**ADDRESS: 3964 W. LAFAYETTE**

**APPLICATION NO: HDC2023-00141**

**HISTORIC DISTRICT: HUBBARD FARMS**

**SCOPE: REBUILD WING**

Area outlined in blue indicates the portions of the walls that will be replaced in kind (entire south wall and parapet and bottom portion of the west wall)

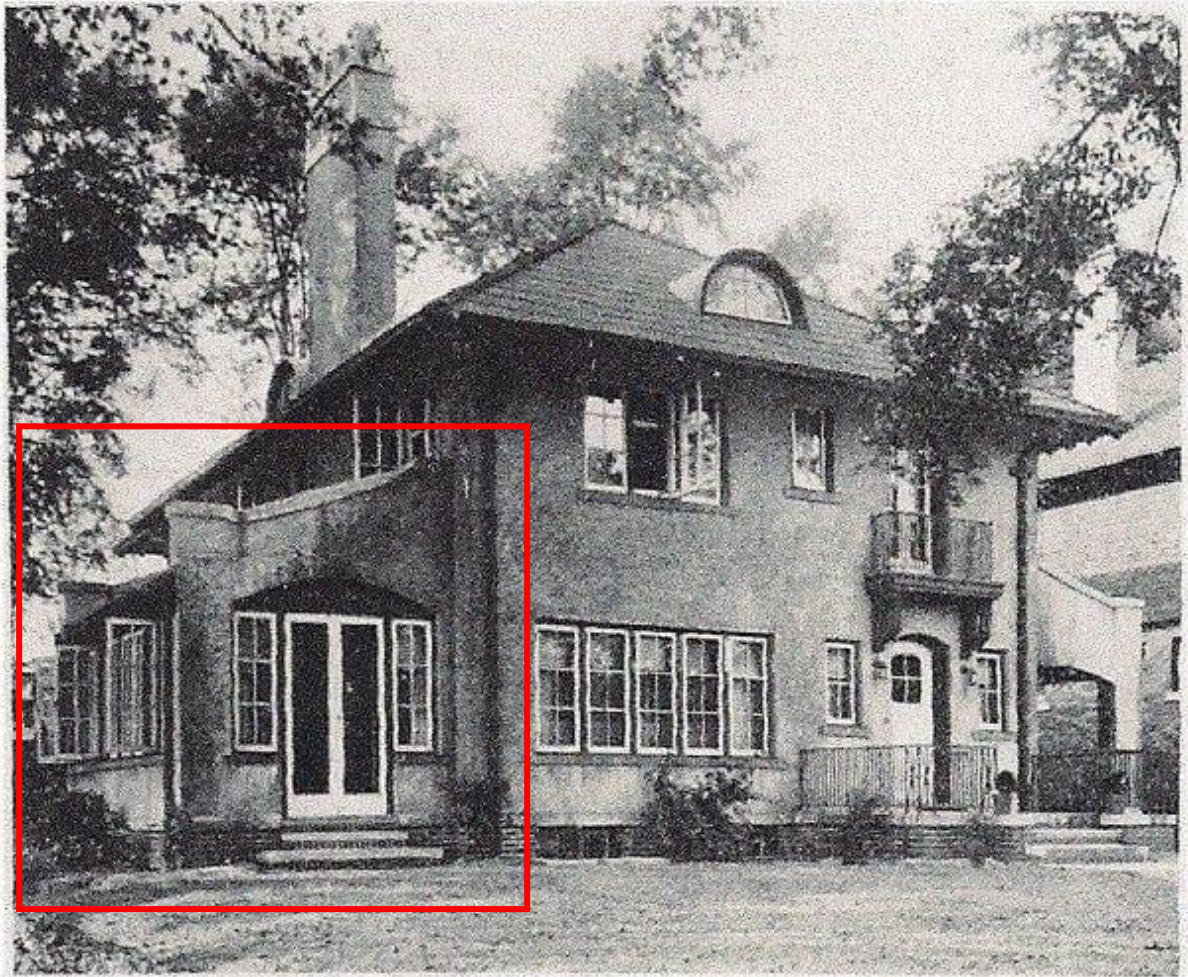
- Remove and rebuild the southern front wall (to include the removal of the existing historic doors and windows). The new southern wall will match the existing in in dimension, cladding and detailing. However the current door opening will not be replicated. Instead, the wall will include four milled, aluminum-clad, wood casement windows (Andersen E Series), topped with arched trim.

- Remove bottom portion of the west wall per the below graphic and rebuild with in-kind materials to match existing in dimension, cladding, and detailing

- Repair deteriorated areas at the north wall with in-kind materials where necessary
- Remove existing wood windows and wood trim to rough opening throughout and replace with new aluminum-clad, wood casement windows (Andersen E Series)

- Install new asphalt shingles at porch roof and replace deteriorated wood soffit and decorative rafters tails with new to match existing in design, materials, and dimension

Western Architect Magazine, dated 1916. Wing proposed for rehabilitation

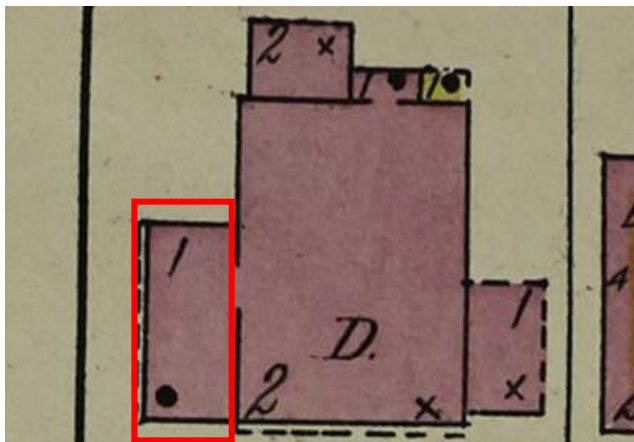
- As noted above, the home was erected ca. 1915. Per the below historic photo dated 1916, the wing proposed for rehabilitation was present at the time of the home's date of construction.
